**Consolidated Statements from Opponents of
the 2nd Story Project at 985 Channing Avenue, Palo Alto**

The plans were received on 08/24/20 for review by Planning Staff. Based on the initial feedback from staff, the application **cannot be deemed complete at this time**. A revised set of plans incorporating the following information and requirements must be submitted for review:

DUNLAP RESIDENCE

985 CHANNING AVENUE
PALO ALTO, CA 94301

2 PROPOSED ROOF PLAN
1/4" = 1'-0"

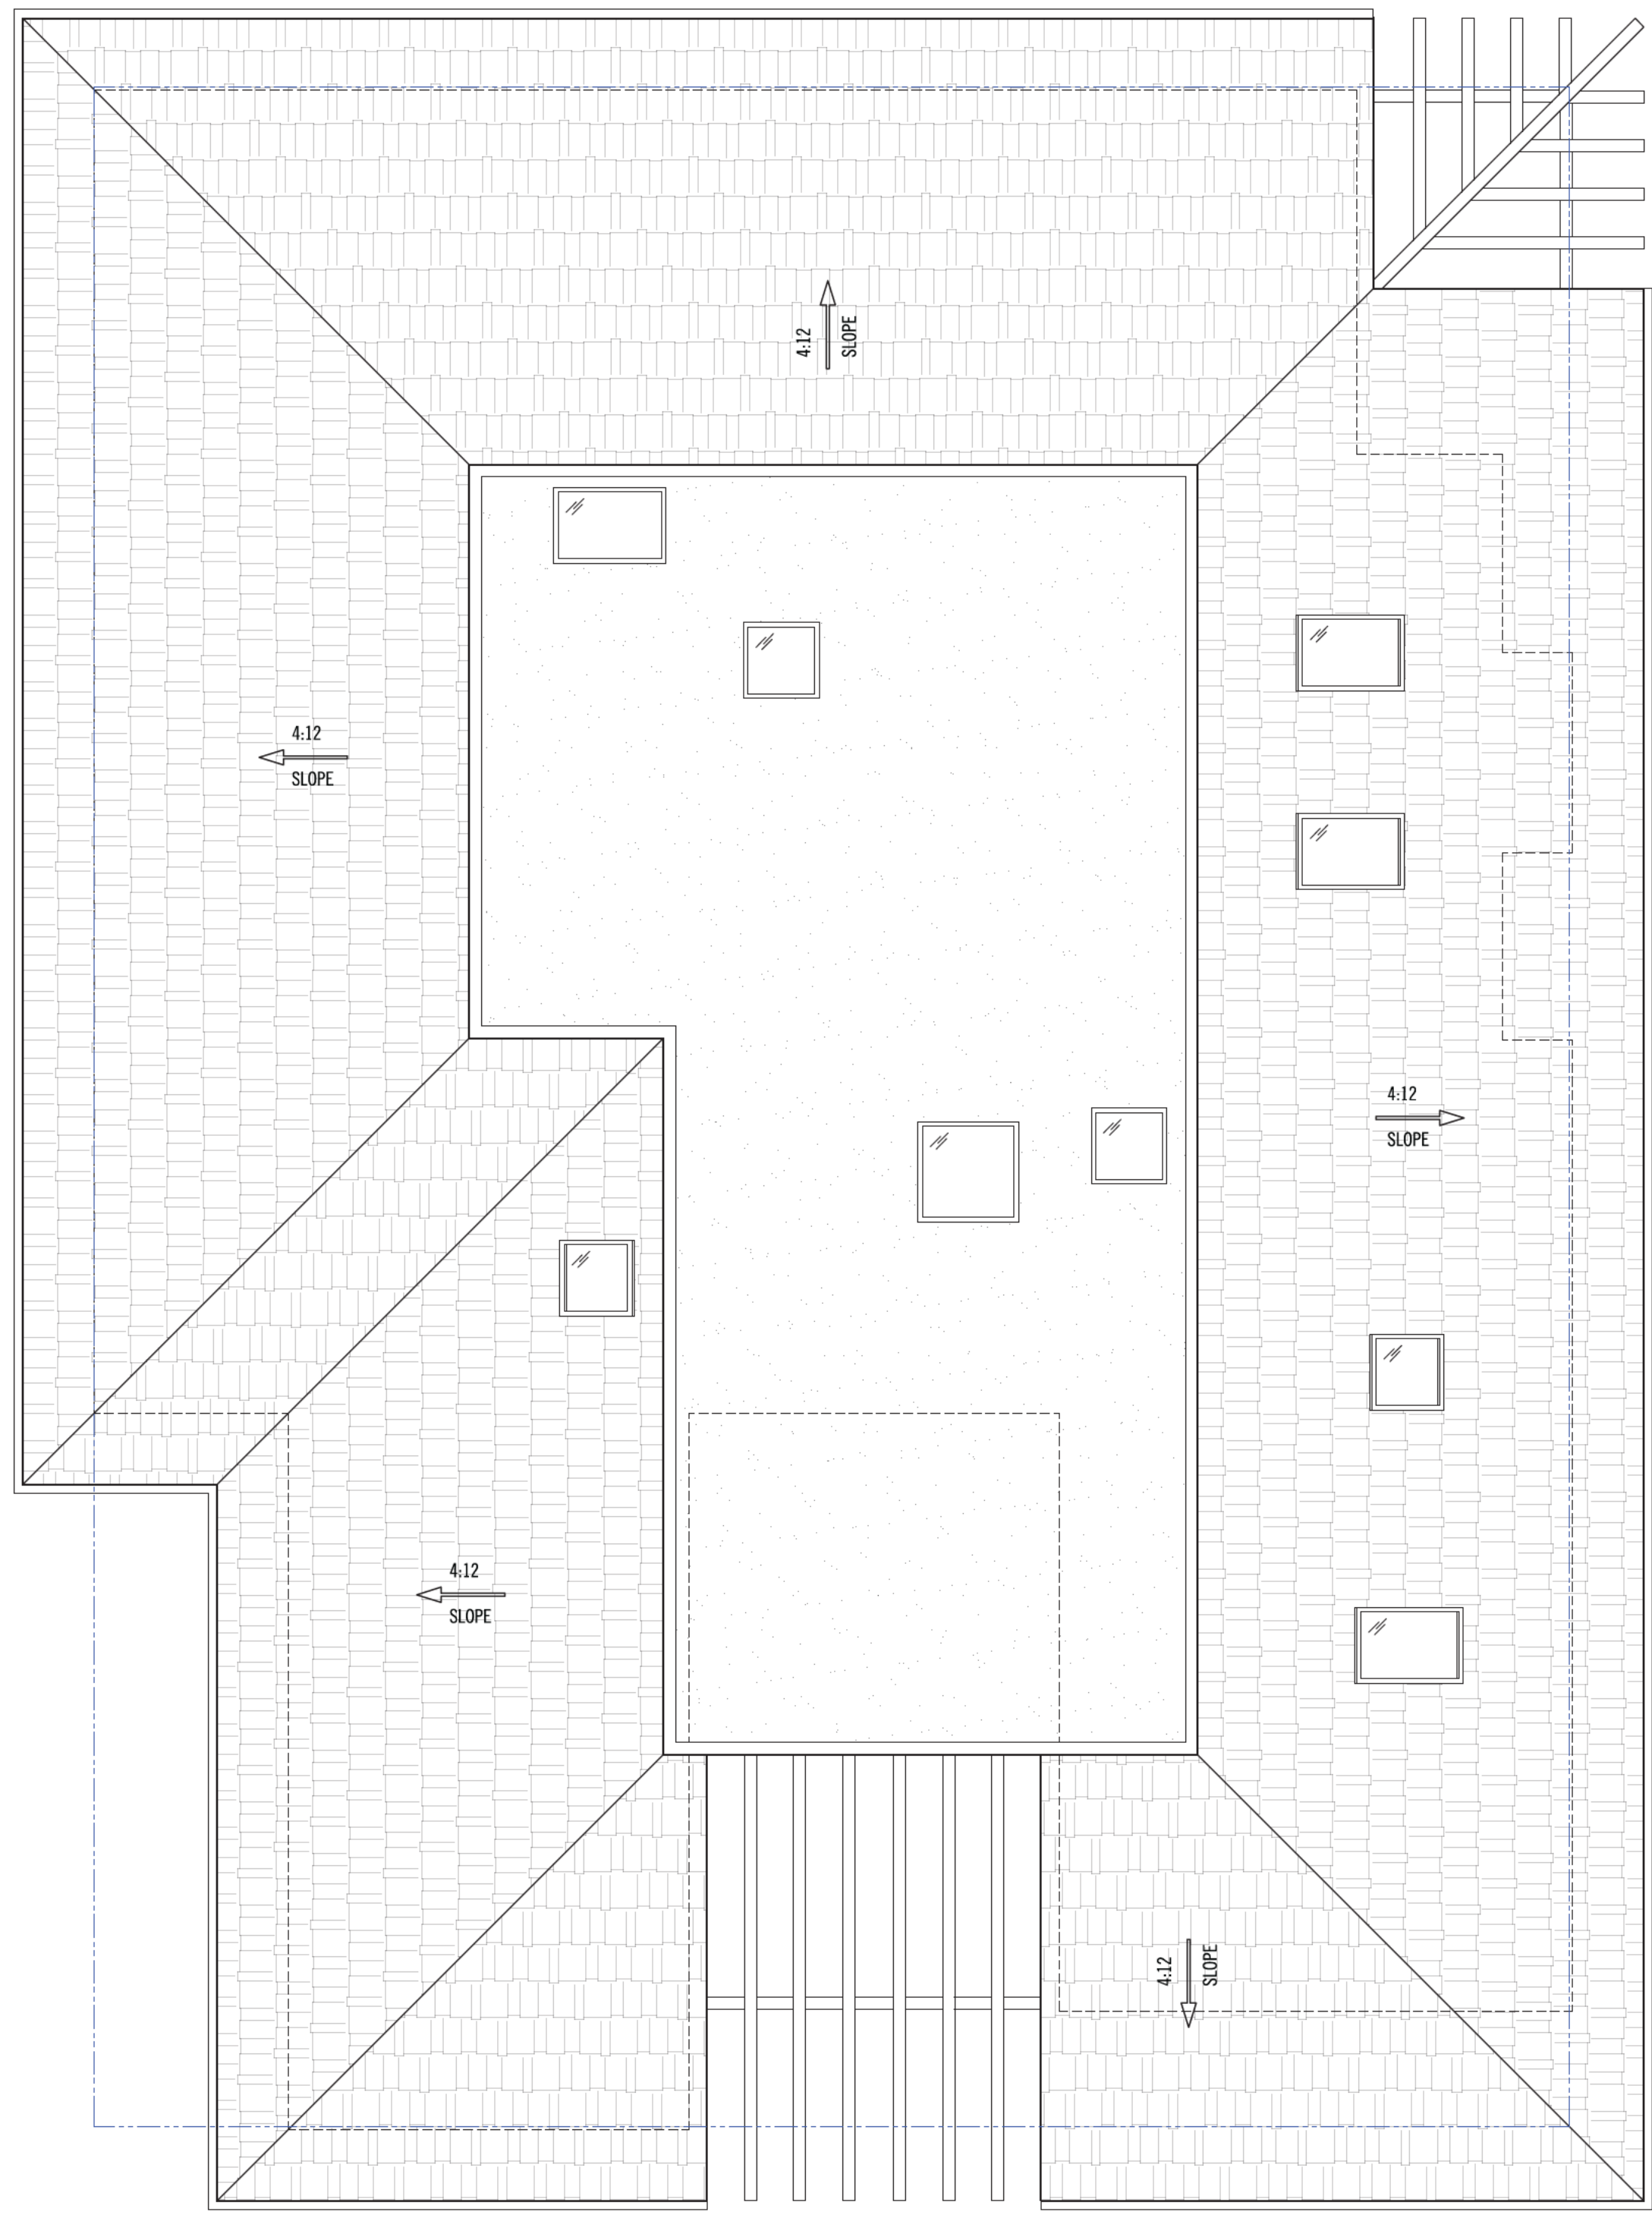
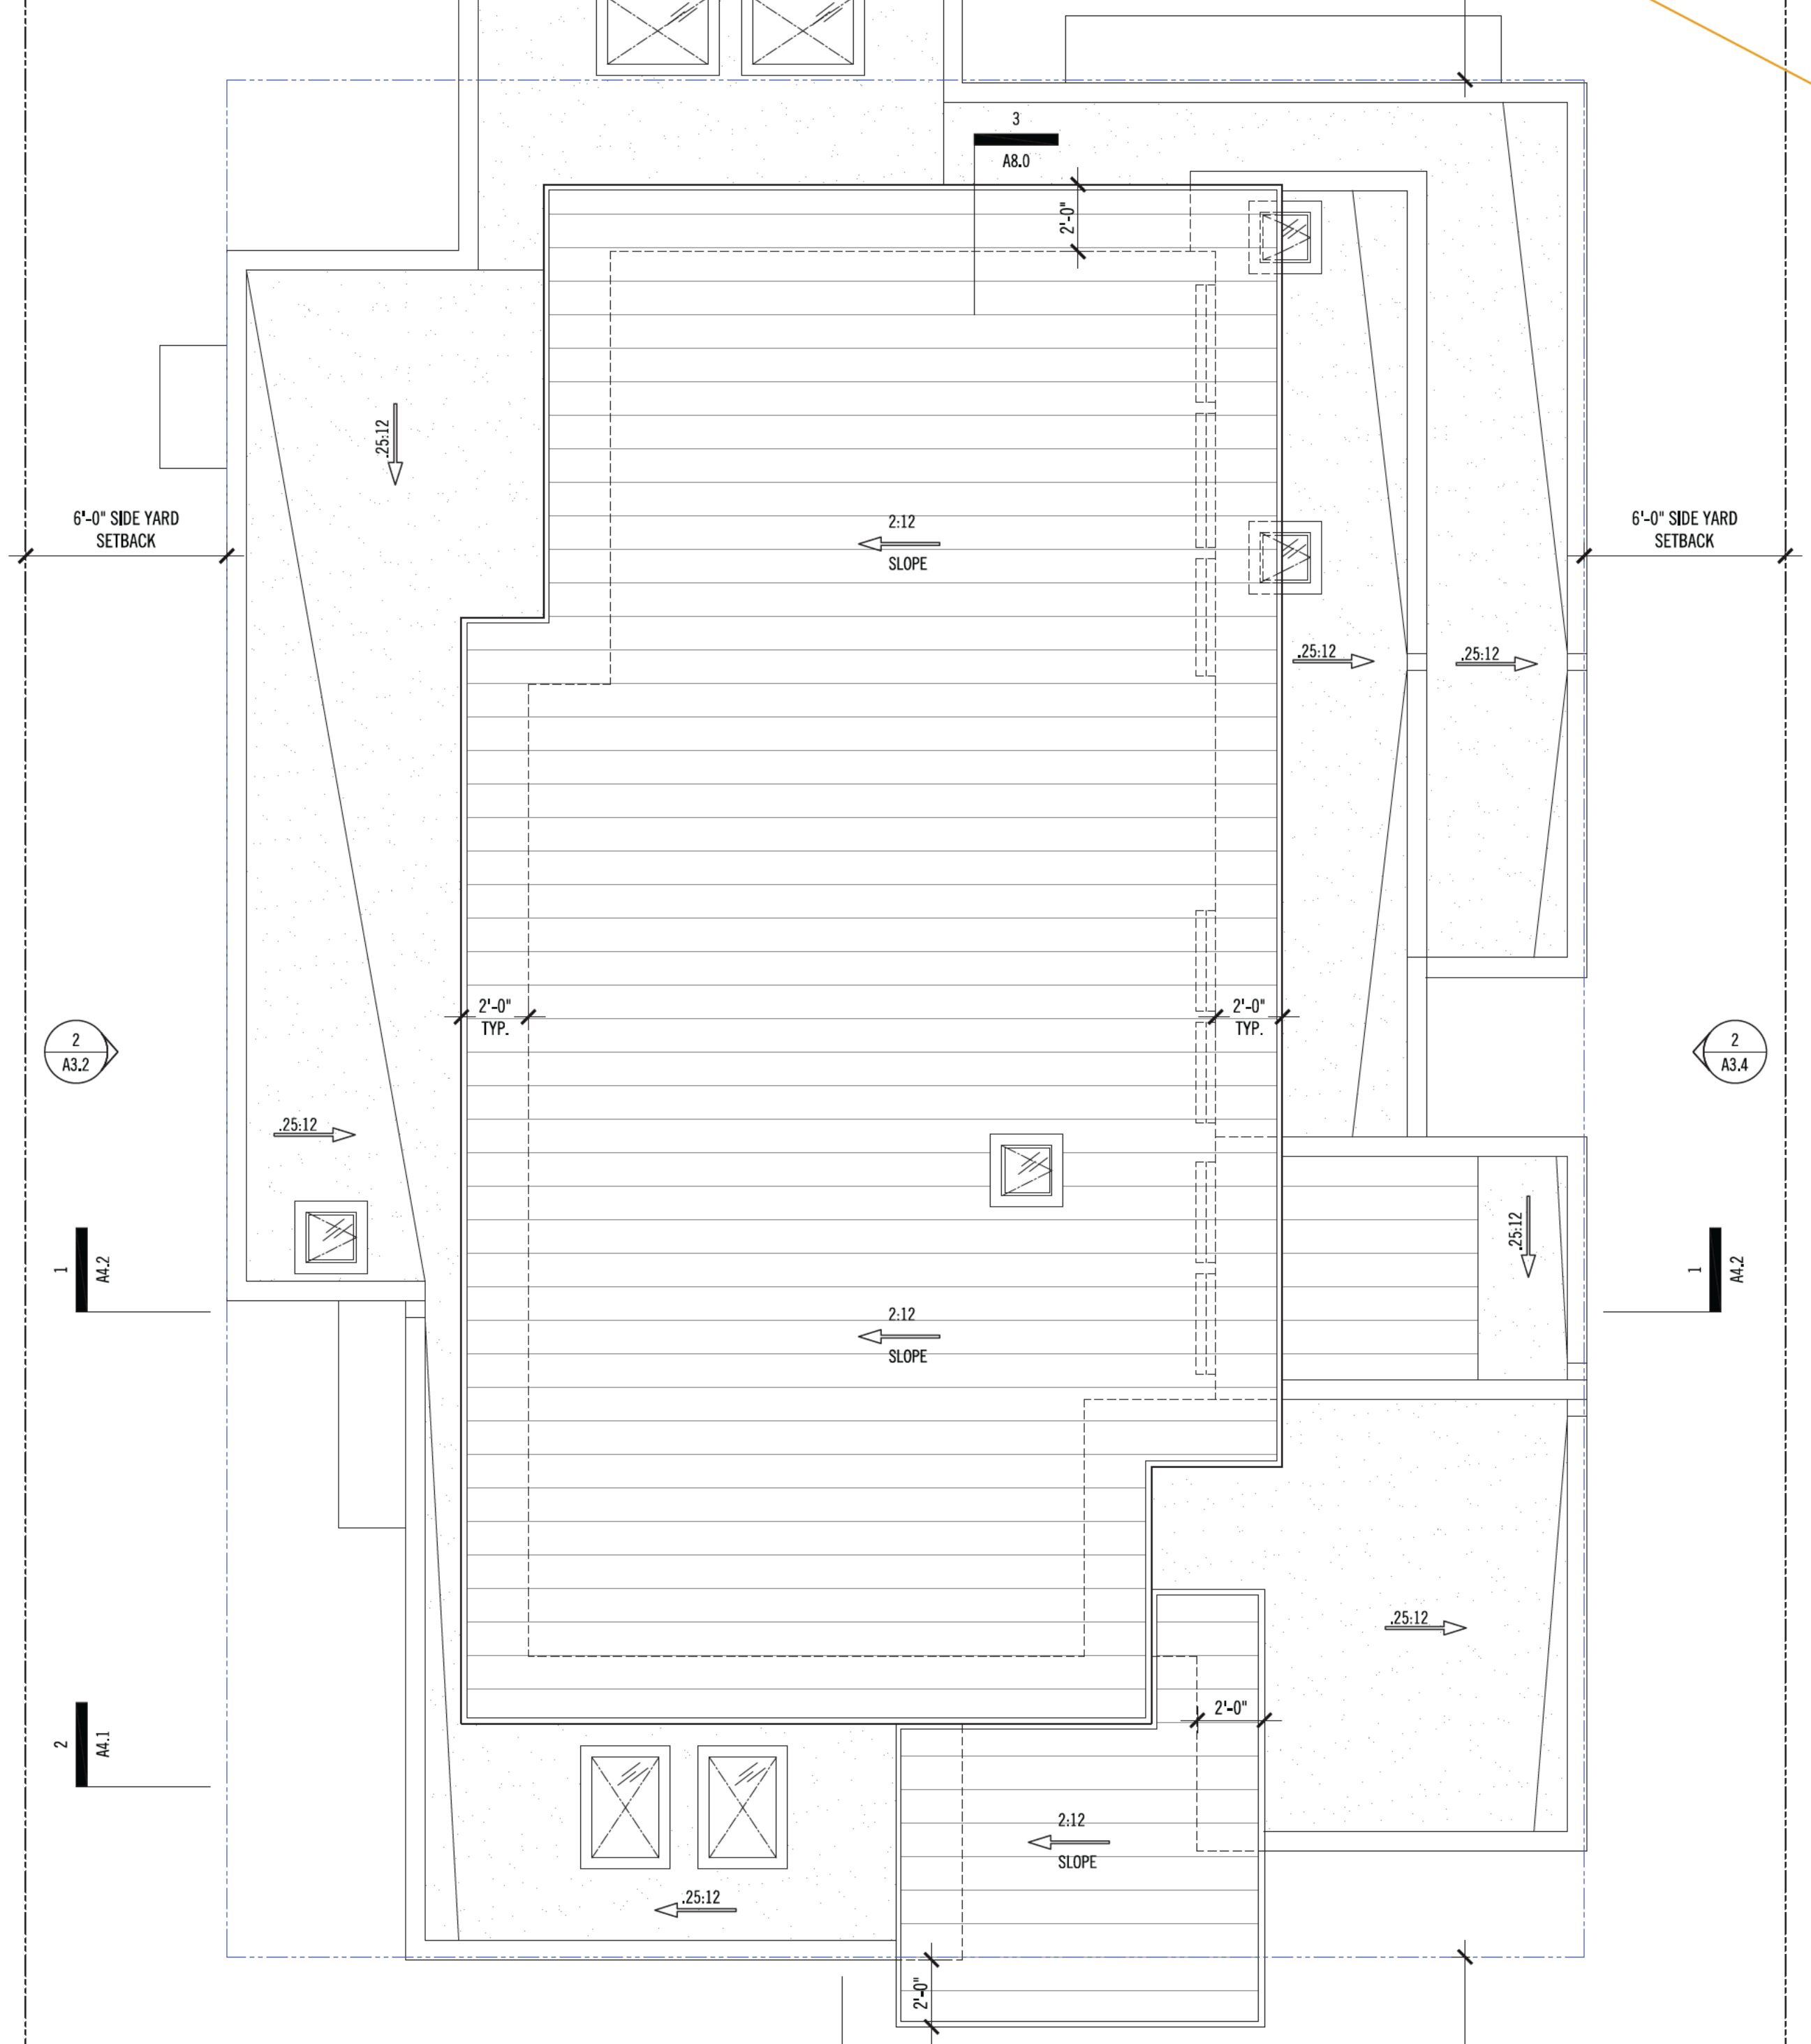
Clarify outline of drawing to identify top of roof and bottom of roof slope.
